March 29, 1993

Hale Fire Pump Company
700 Spring Mill Avenue

SUBJECT: MODEL VPS POWER SHIFT DESIGN MODIFICATION

PARTS LIST HALE TYPE VPS POWER SHIFT PLATE NO. 533C

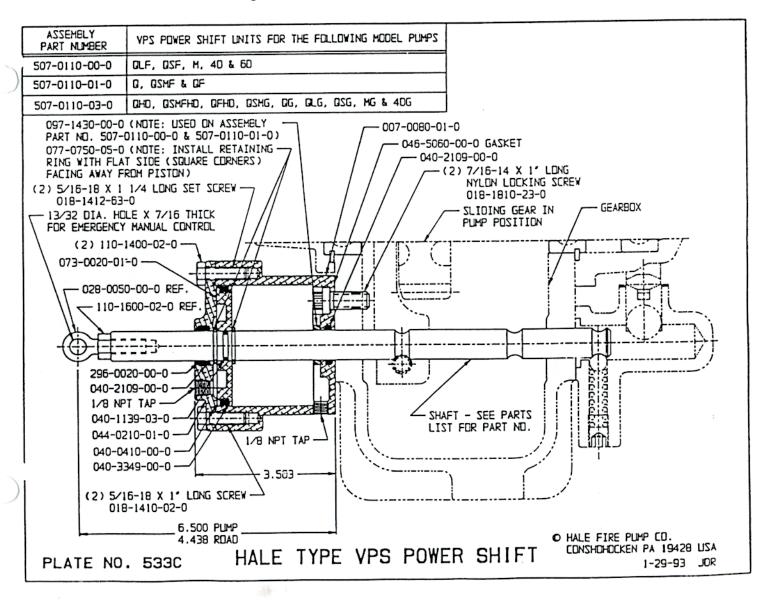
Hale Cross Sectional Plate # 533C is enclosed for your convenience and to relate to the area of change. Note the shifting shaft Part No. 037-1341-00-0, is shorter, and equipped with a rod end to allow easier access and replacement of the shift cylinder sealing rings. The new design will permit the removal of the necessary shift cylinder parts for this repair without the removal of the vehicle drive line and flange assembly from the pump gearbox.

However, be advised that this relatively minor change could have some small impact on your manufacturing if you have a fixed design for a pump shift override mechanism. Our previous design provided a 1/2" diameter cross hole in the shift shaft for manual override purposes. Our new design will shorten the shift shaft and replace the through hole with a tapped hole in the end of the shaft, fitted with a rod end (eye bolt). The rod end will serve the purpose of attaching a manual override if required or provide a method for shift override if necessary by inserting a drift pin or screw driver in the rod end.

Implementation of this change is anticipated April 1, 1993.
